August 30, 2024

ADDENDUM NO. 1

Latino Community Credit Union - Morrisville Project

1 ELECTRICAL FLOOR PLAN
 E101 1/4" = 1'-0"

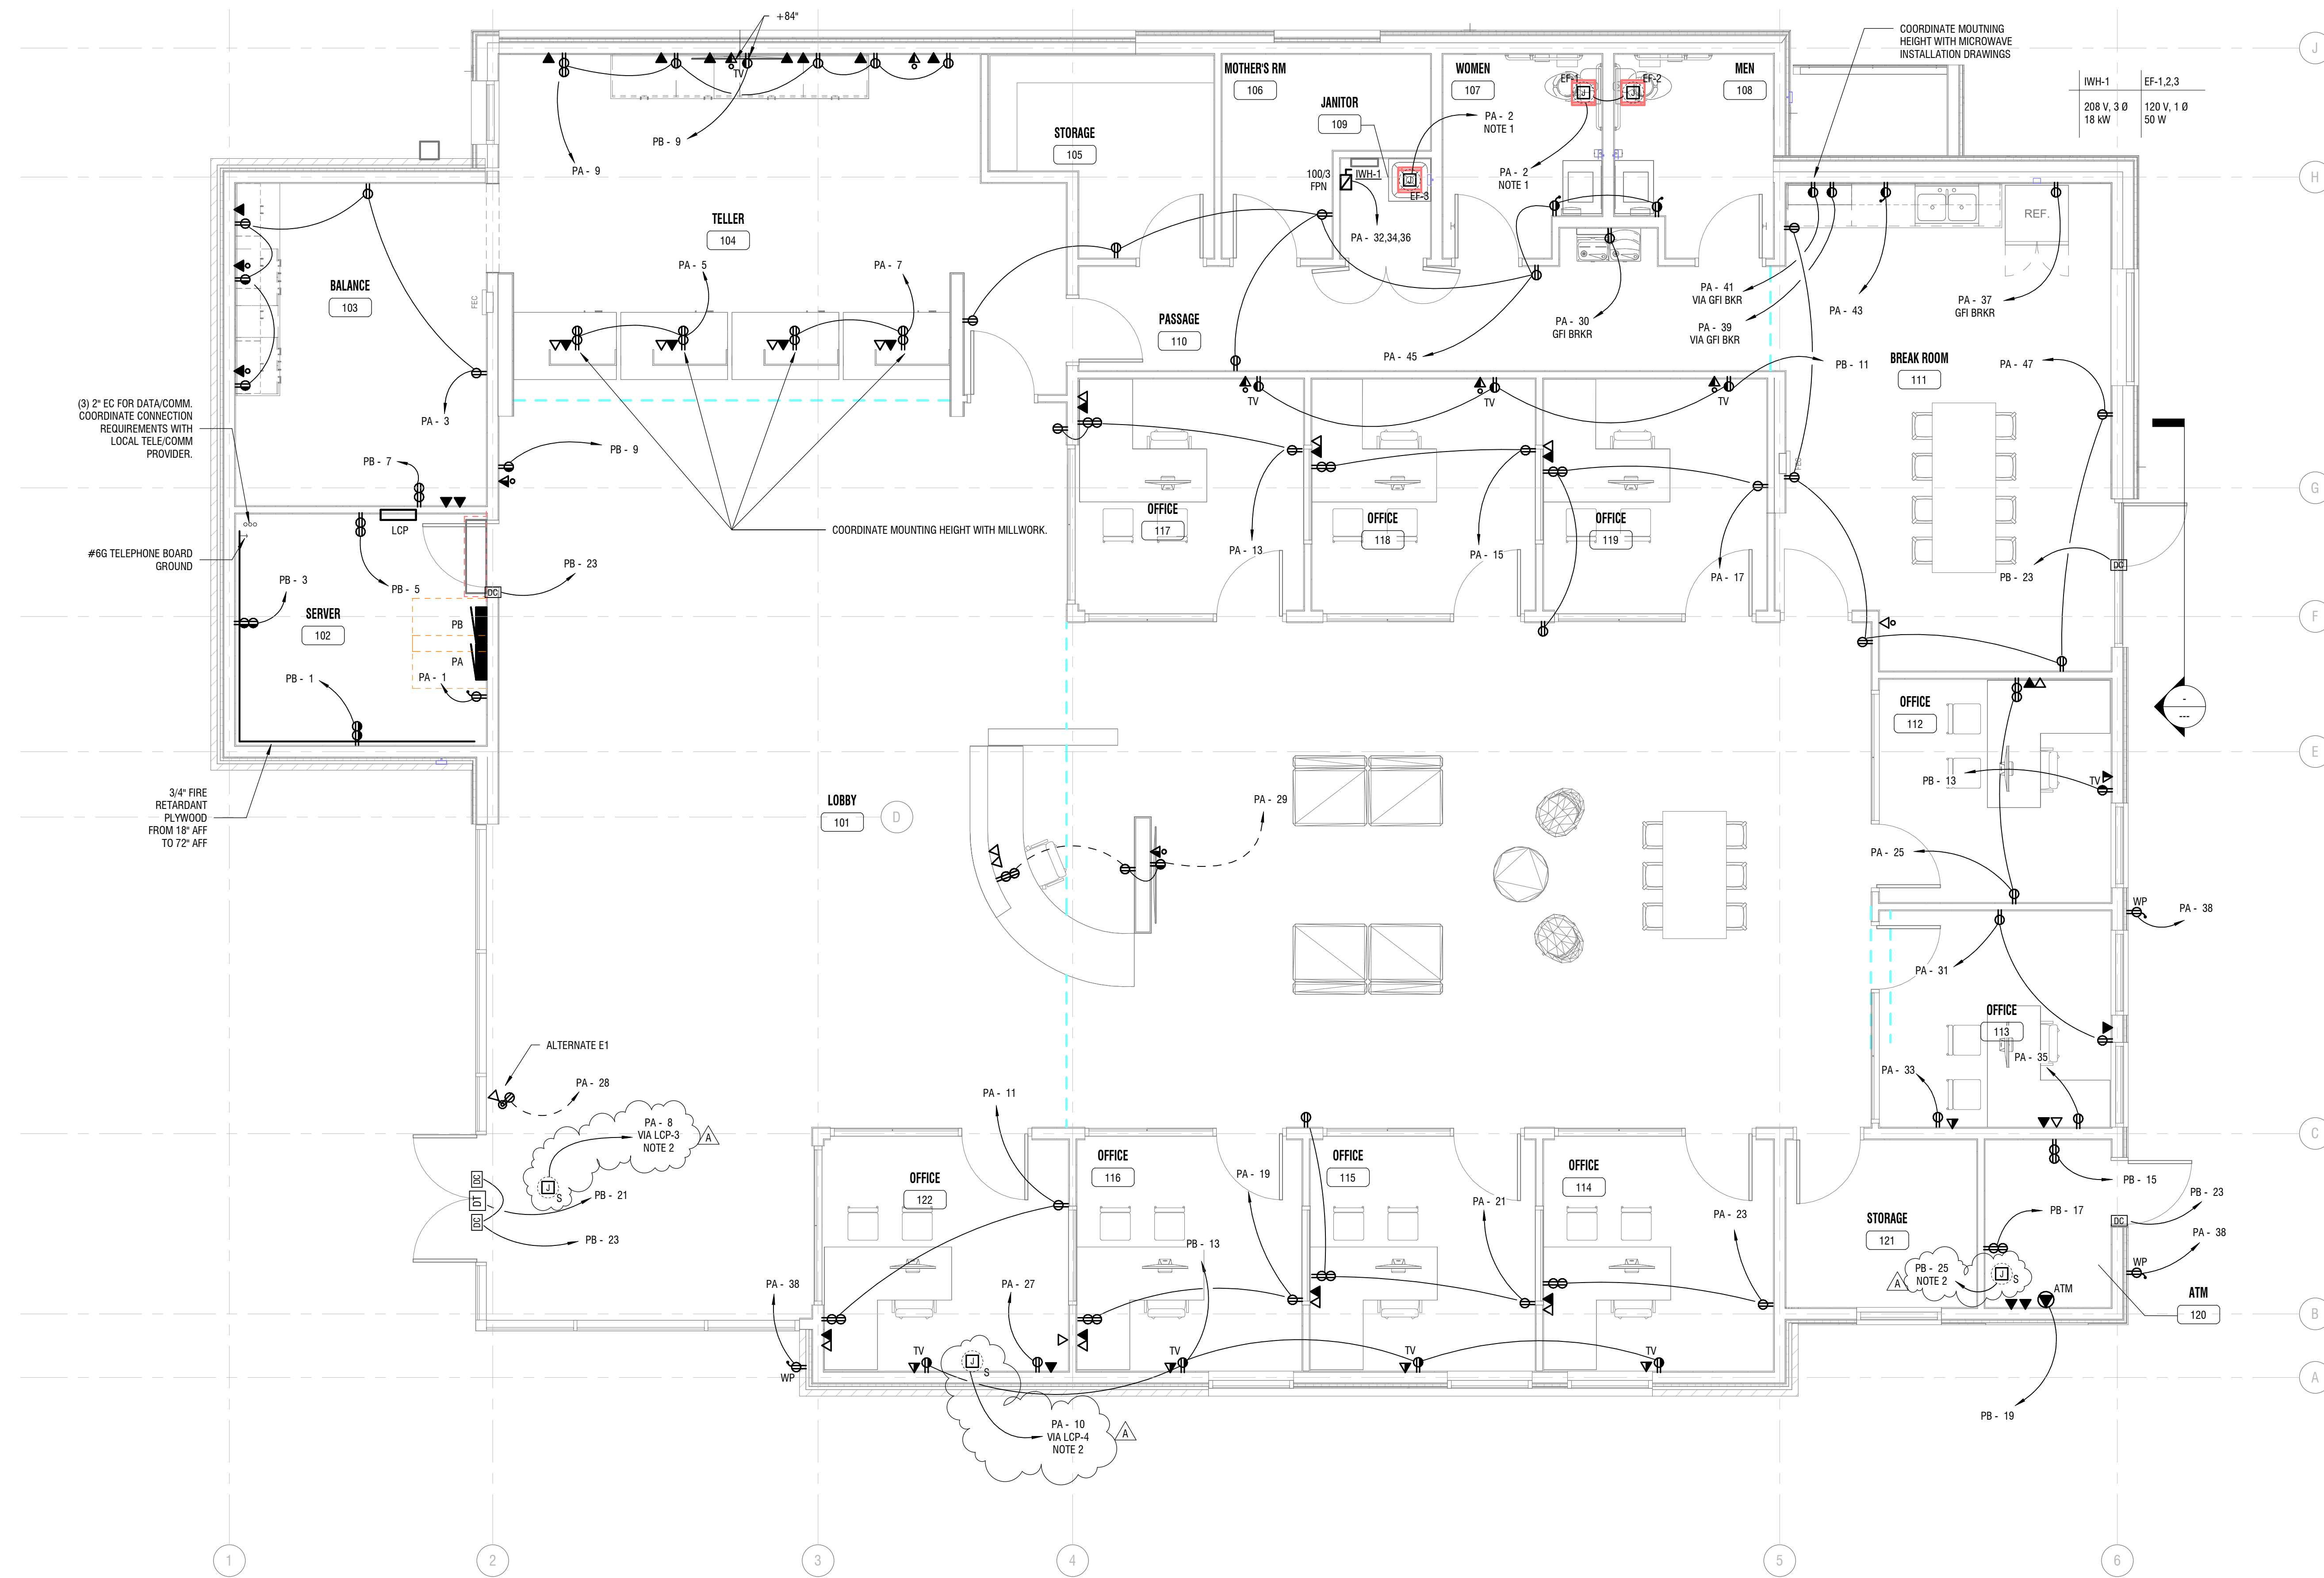
ALTERNATE E1
 - INSTALL POWER AND DATA COMBINATION RECEPTACLE FOR COIN SORTER.
